**AMENDMENTS TO THE DRAWINGS**

### **REMARKS**

WHALEY

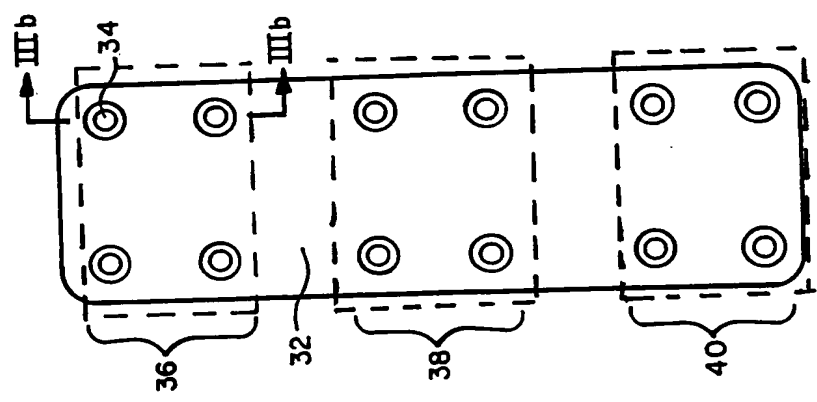
Includes only one subset of holes (50).  
 Remaining holes (46, 48) cannot be construed as a subset because limitations of the independent claims requires that the base include a set of holes configured in the same pattern as the first and second subset of holes of the plate. The inherent design of the Whaley plate allows for only one subset of holes that is adapted to mate with the base.

PRESENT INVENTION

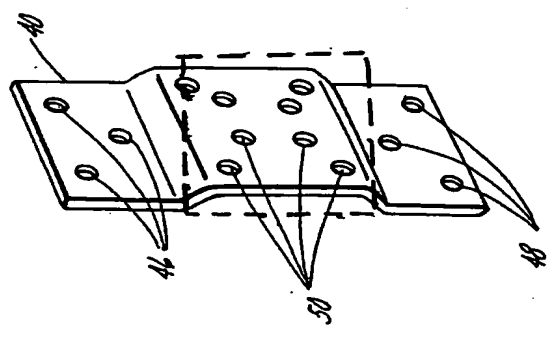
At least a first and second subset of holes, each subset corresponding to the pattern of holes on the base.

Fig 2

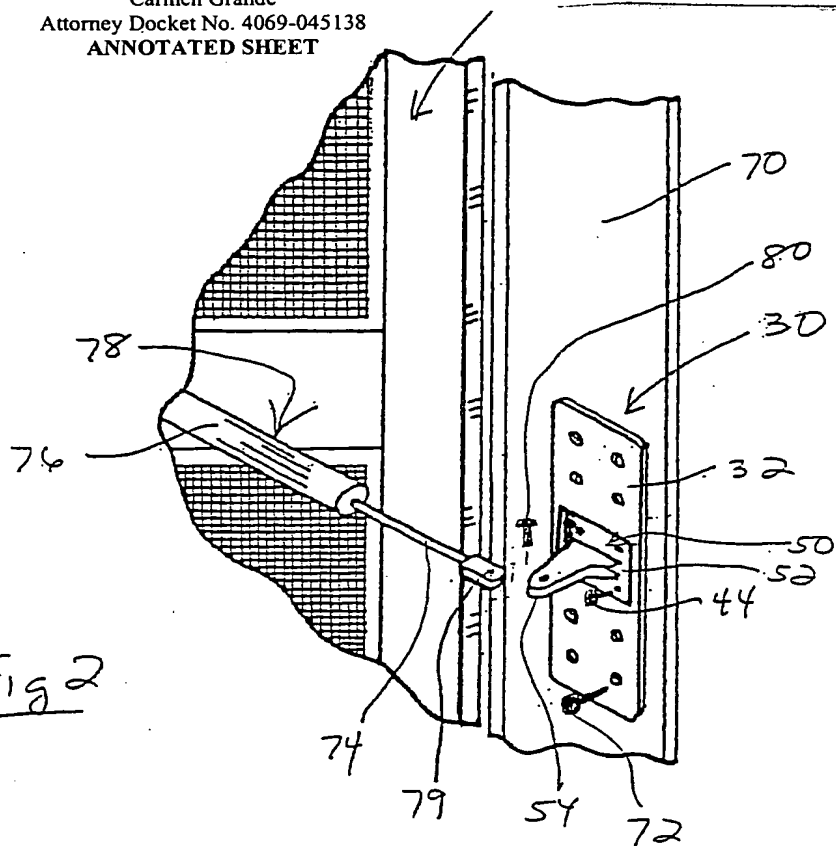
In amended FIGS. 2 and 5, the base (52) has been resized with shifted holes (60) to correspond to the upper and lower set of holes on the plate (32). Thus, the hole pattern on the base (52) corresponds to any subset of hole patterns on the plate (32). The Applicant has submitted formal drawing sheets for FIGS. 1, 2, 3a, 3b, 4a, 4b, 4c, 5, 6, and 7, which include the aforementioned amendments to FIGS. 2 and 5.

The drawings stand objected to because the Examiner asserts that FIGS. 2, 5, and 3a appear to be inconsistent. The Applicant believes that new FIGS. 2 and 5 overcome the Examiner's objections. Amendments to FIGS. 2 and 5 are indicated in red in the attached annotated copy of FIGS. 2 and 5. Reconsideration of these objections is respectfully requested. Entry of formal drawings sheets for FIGS. 1, 2, 3a, 3b, 4a, 4b, 4c, 5, 6, and 7 is also respectfully requested.
